**Re: Order of Conditions, DEP File No. 006-1648
Parkway Apartments
1545 – 1555 VFW Parkway, W. Roxbury, MA.**

On behalf of Lincoln Parkway, LLC (the “Proponent”), Howard Stein Hudson and Epsilon Associates, Inc. respectfully submit this Request for an Amendment to the Order of Conditions (OOC) issued on April 17, 2019 for the above-named Project, to delete Special Condition No. 68 from the OOC, and to approve a minor plan change to increase the amount of compensatory flood storage.

**Re: Parkway Apartments Order of Conditions, DEP File No. 006-1648
Engineering Certification/Minor Plan Modification Regarding Base Flood
Elevation and Compensatory Flood Storage**

C1.01

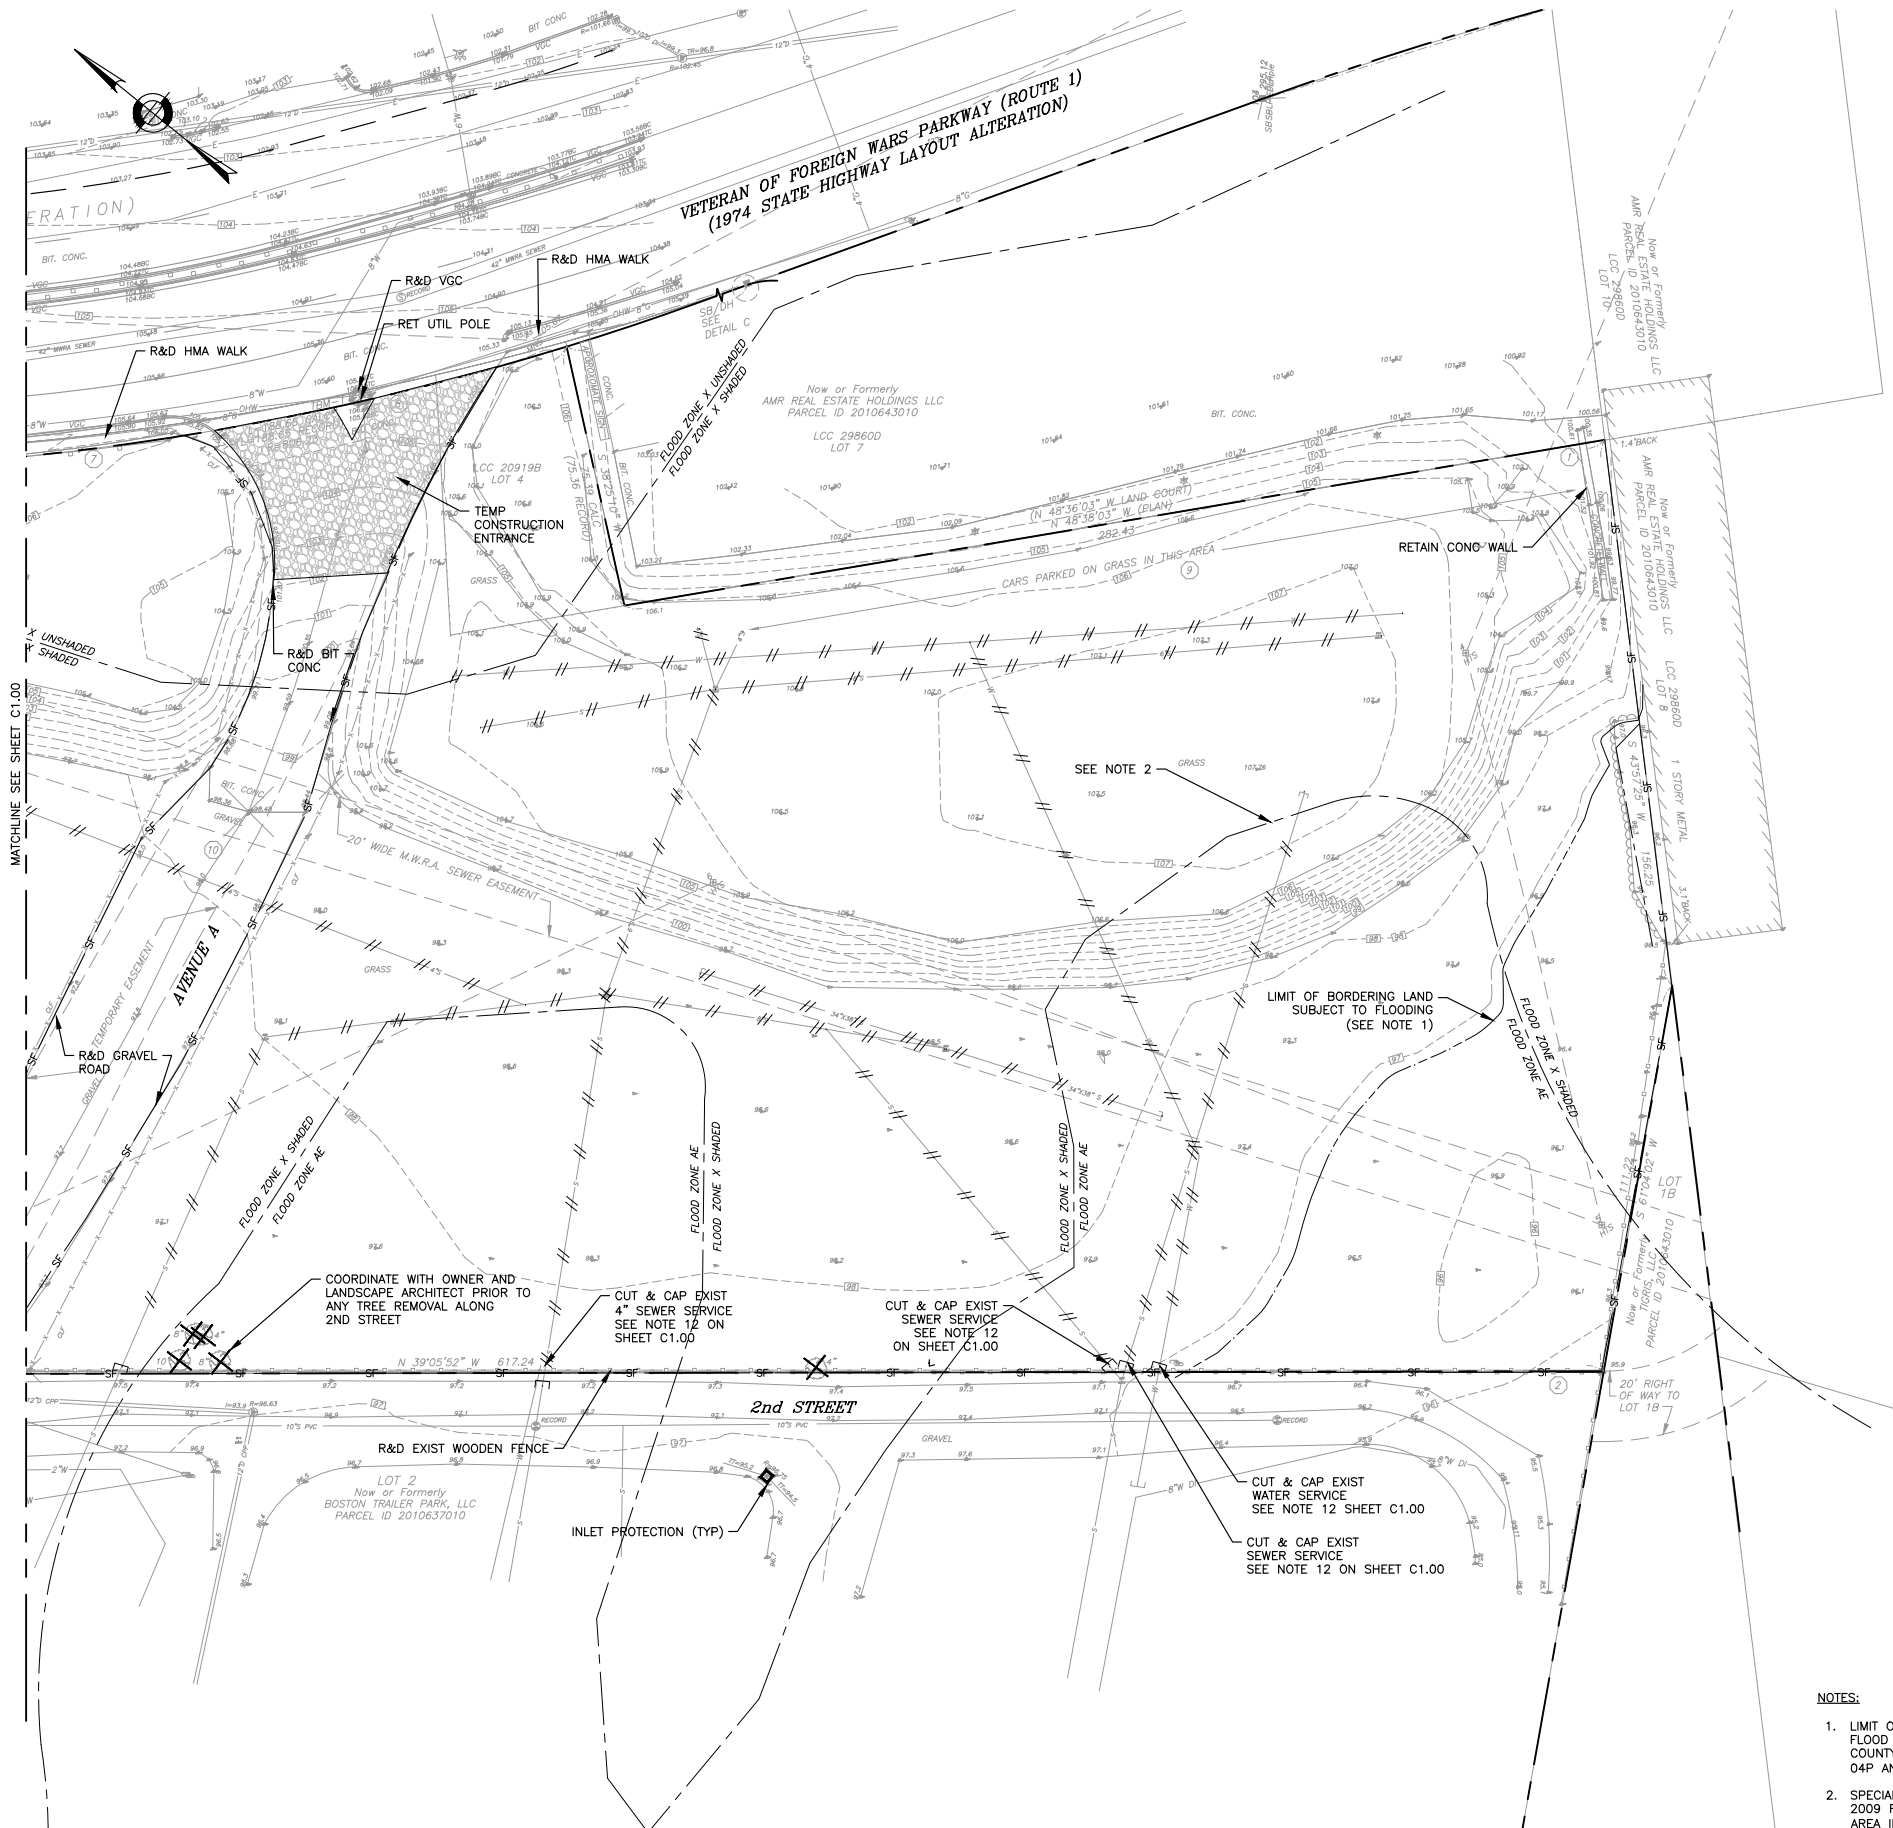
Further, the Proponent respectfully requests (to the extent not already fully addressed at the October 9, 2019 Commission meeting) that the minor plan change reflected in the September 6, 2019 Final Plans to increase the extent of compensatory flood storage be approved, either as an administrative change or an Amendment to the approved OOC Plans. The Proponent has revised the Plans with respect to compensatory flood storage on site to reflect a more conservative Base Flood Elevation (“BFE”) as provided in the 2016 FEMA Flood Profile for the project area of 90.4 feet NAVD 88, instead of 90 feet as described in the original Notice of Intent application. This results in a slightly increased

amount of work in the floodplain (limited to site grading and a portion of the building). The compensatory flood storage provided to mitigate this impact meets the requirements of 310 CMR 10.57(4)(a)1. As documented in the September 6, 2019 submittal, the Project as modified provides an increase in flood storage capacity (an additional 645 cubic feet) compared to pre-development site conditions. Accordingly, the Proponent requests that the Commission approve this minor plan change.
